May 14, 1993  
LIC-93-0146

SUBJECT: Request for Additional Information Concerning the Fort Calhoun Station Spent Fuel Pool Rerack (TAC No. M85116)

OPPD Responses to April 8, 1993  
NRC Questions on the FCS Spent Fuel Pool Rerack

Fig. 7 Hydrodynamic Pressure on South Wall, DE Seismic.

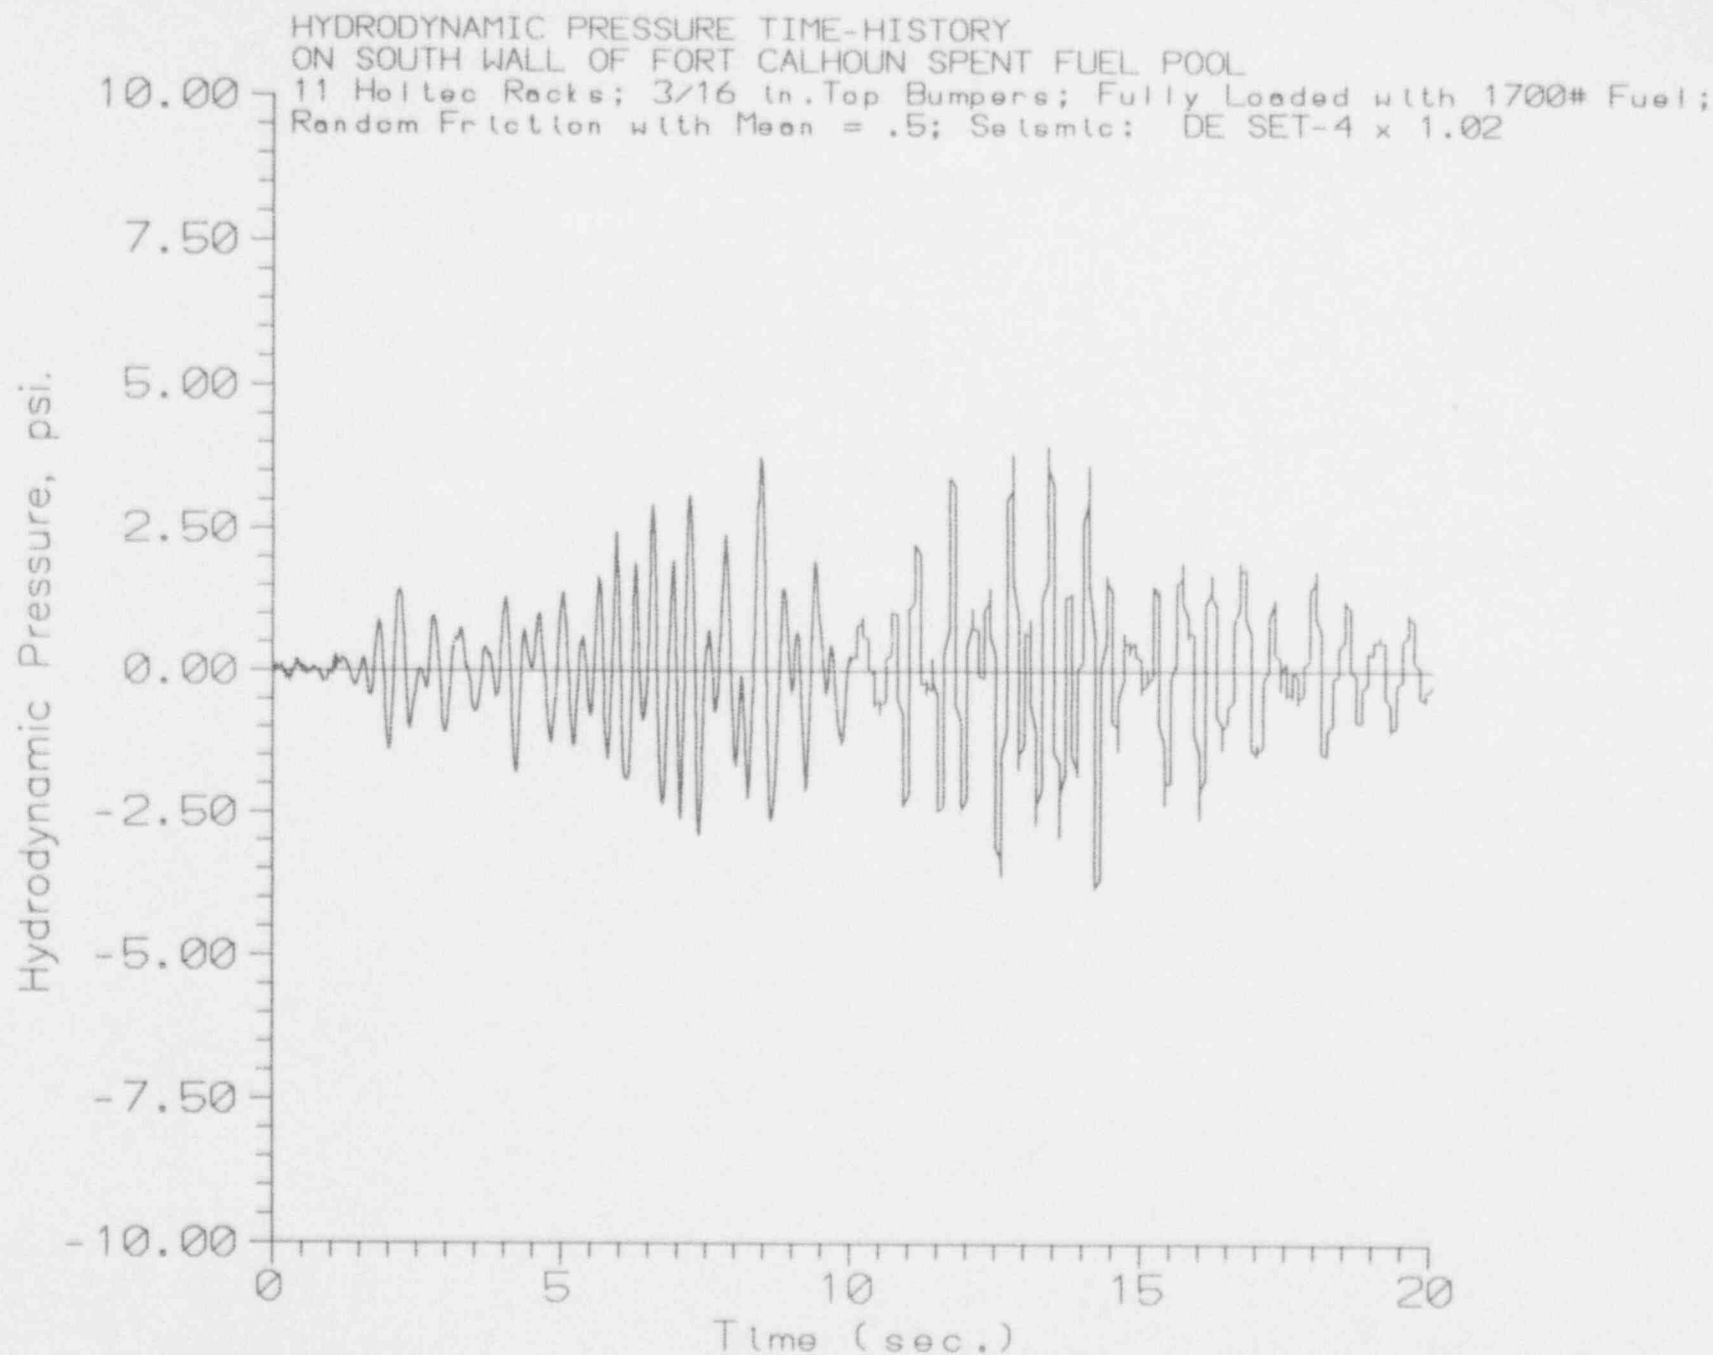
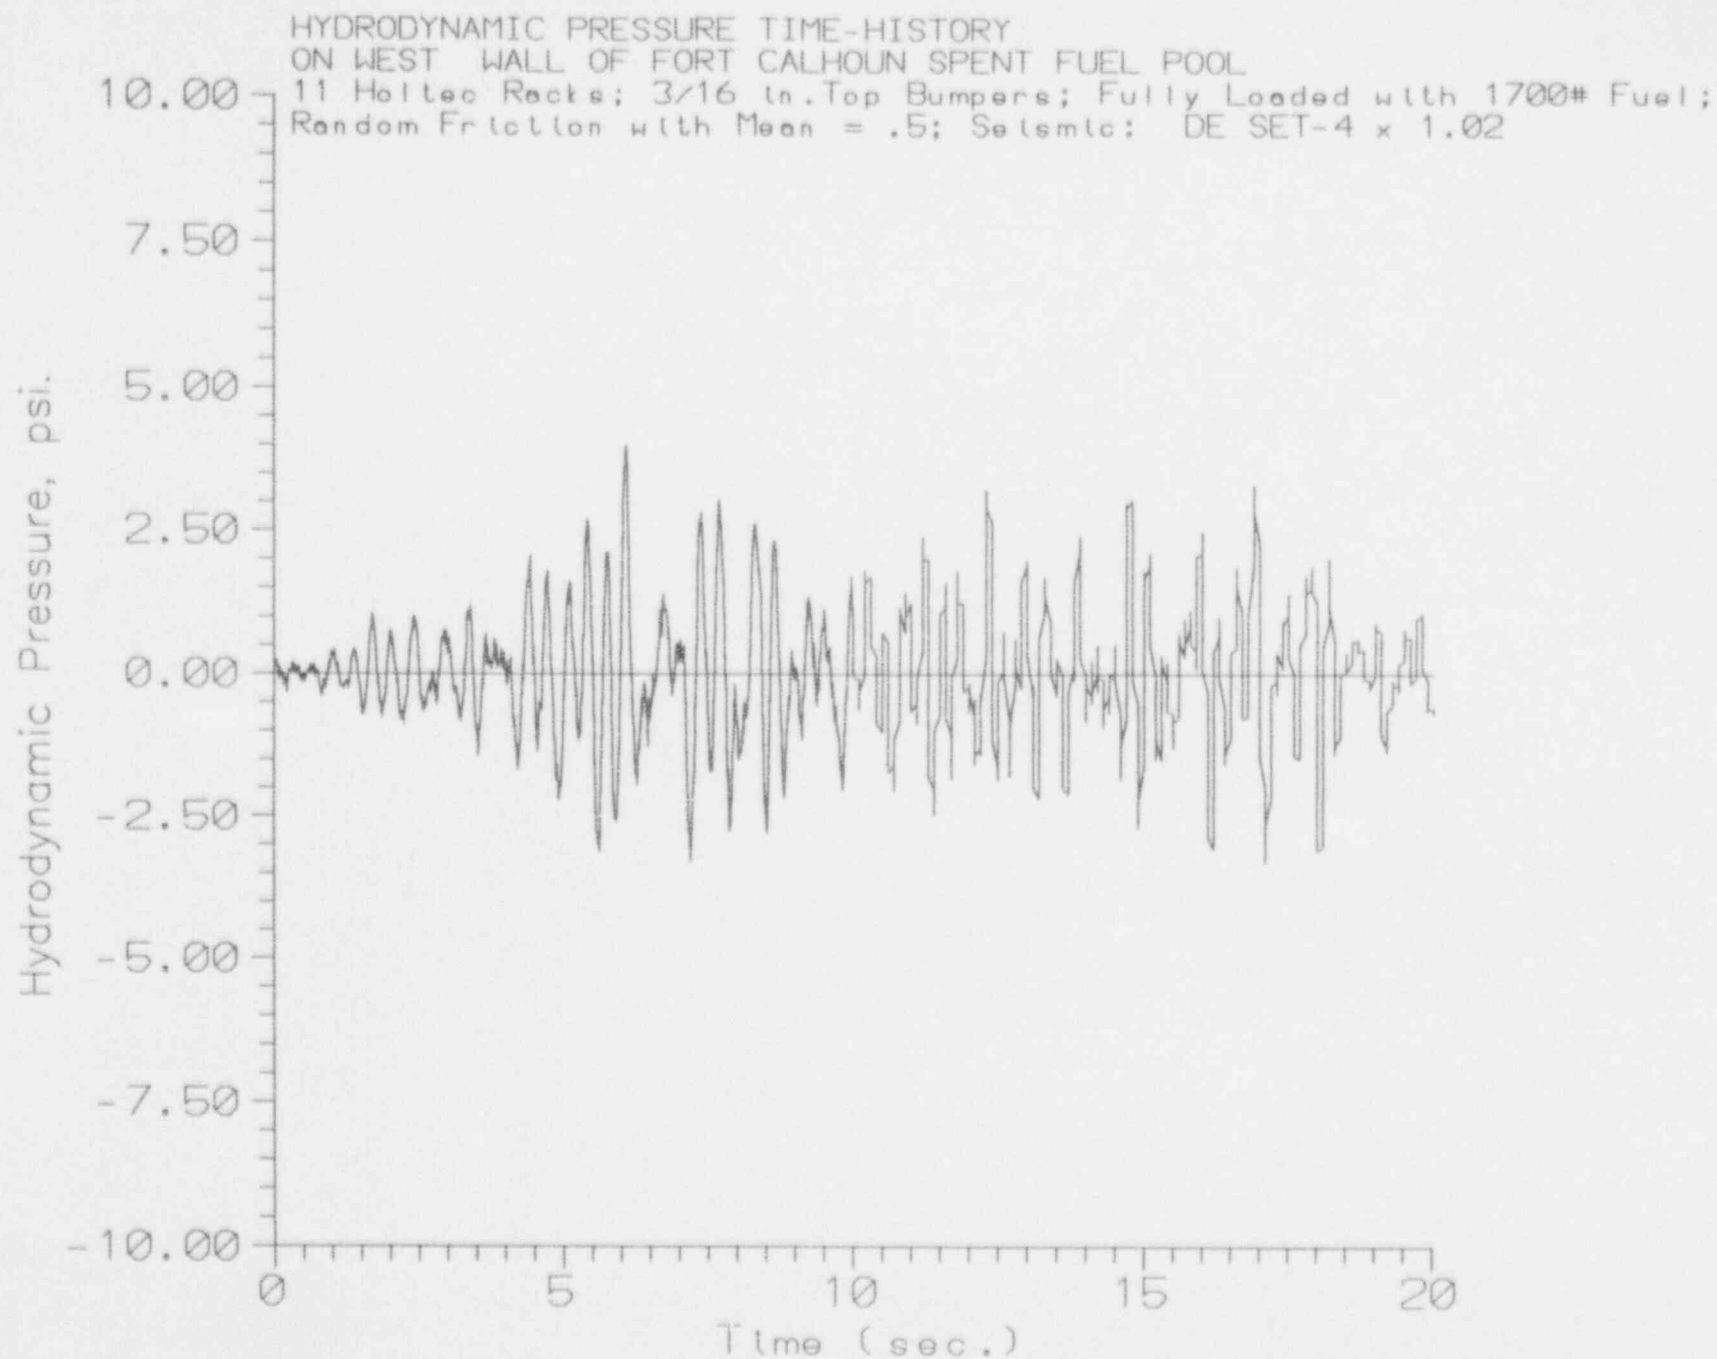
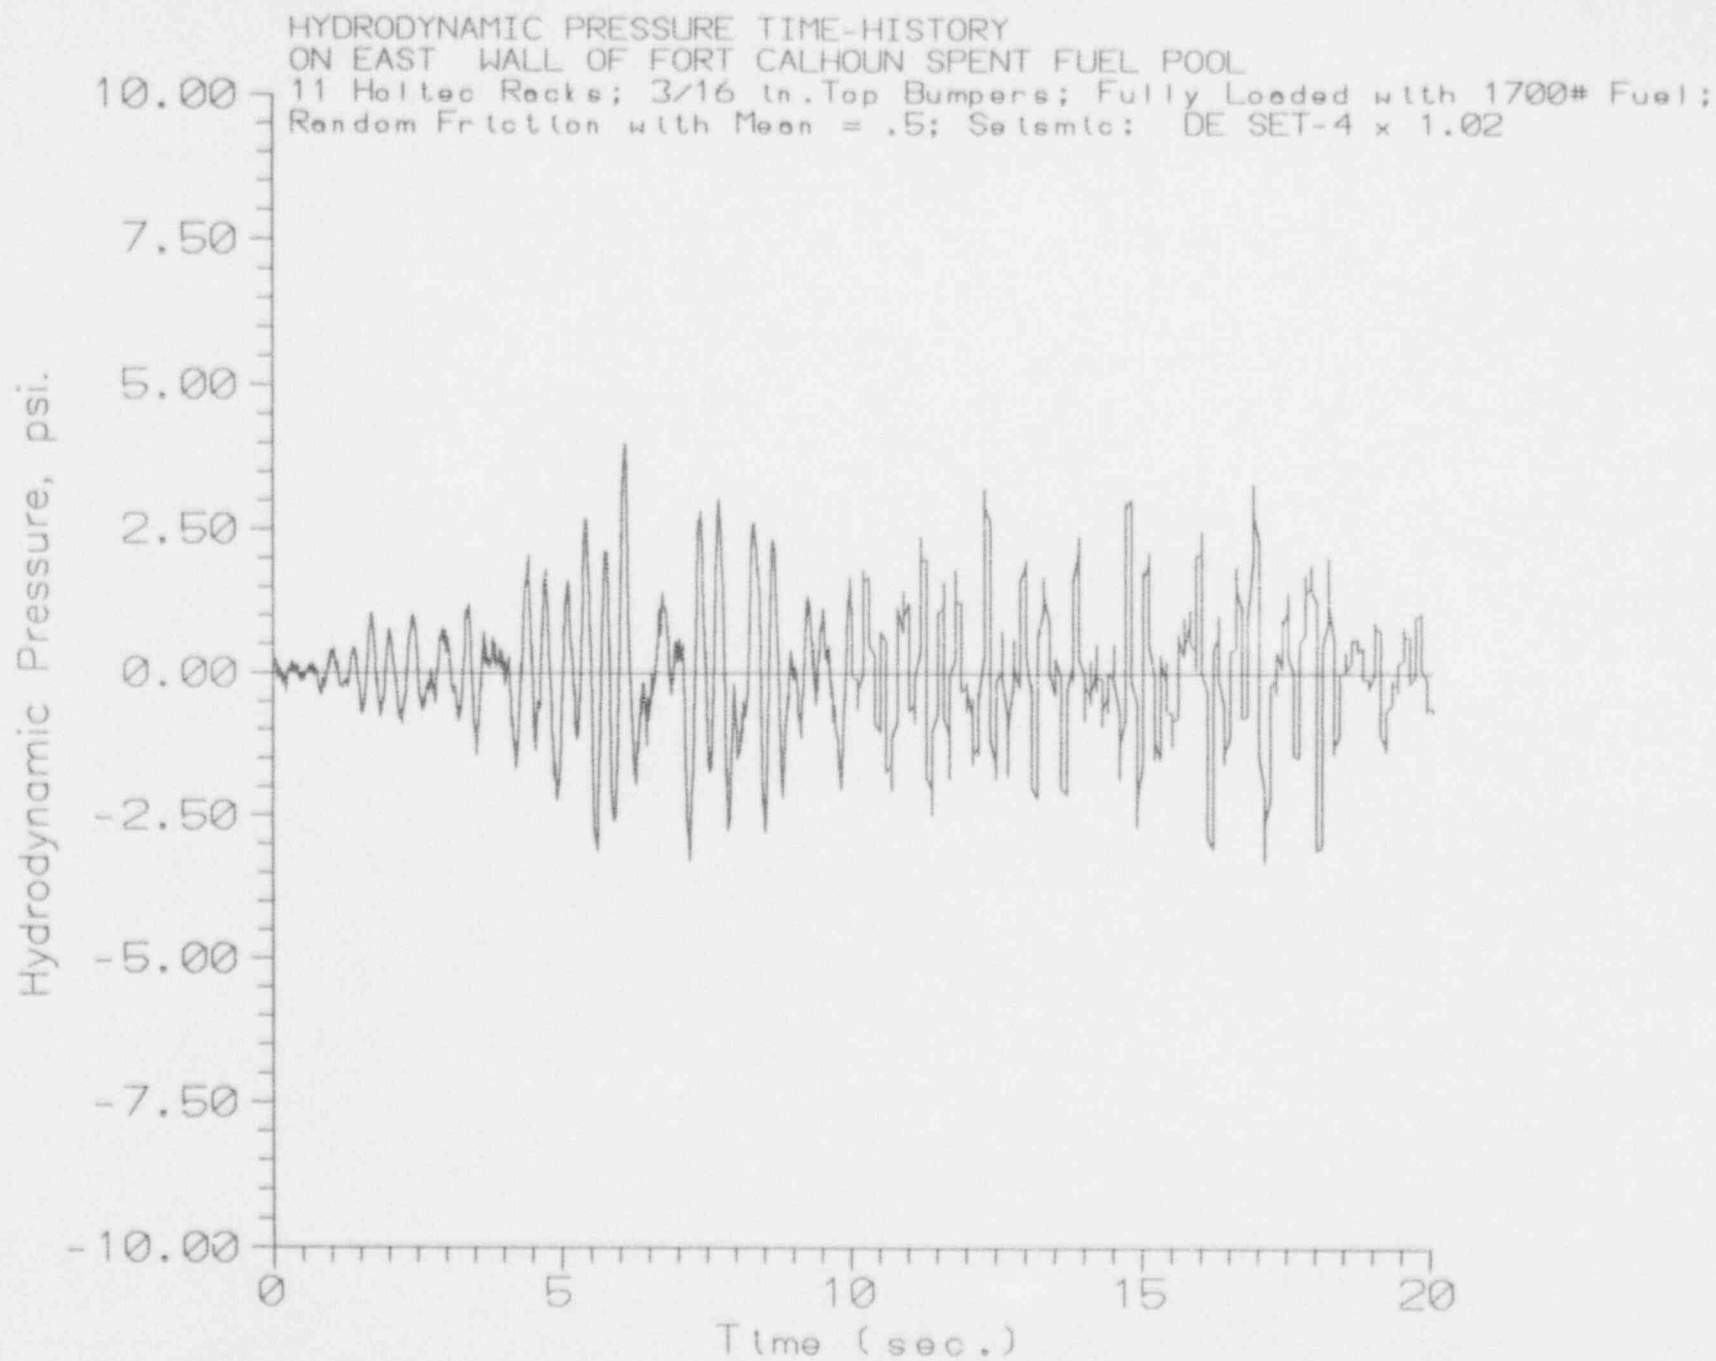
Provide the largest magnitude of the fluid pressure distribution along the height of the rack during the fluid and rack interactions for each case of the 3-D single and multi-rack analyses. Also, provide results of any existing experimental study that verifies the simulation of the fluid coupling utilized in the numerical analyses. [Note: OPPD is requested to provide results of experimental study in addition to the experimental study indicated in Reference Section of the submittal. The experimental study mentioned in Reference Section does not reflect realistic rack configuration, boundary conditions, rack and fluid interaction, and dynamic input loading conditions.]

The hydrodynamic pressure due to the relative movements between the assemblage of racks and the pool wall is available from the Whole Pool Multi-Rack (WPMR) analyses. The pressure distribution between the pool wall and the facing rack walls is utilized in pool structural evaluation and is therefore saved in the output files. The dynamic pressure time-histories on the walls for the WPMR analysis runs reported in the Reference 2 submittal are presented in attached Figures 2 through 9. Figure 10 shows the pool layout. Please note that the change in appearance of each plot beyond 10 seconds is due to the program not saving the time step to enough significant figures. The magnitudes are correct, however.
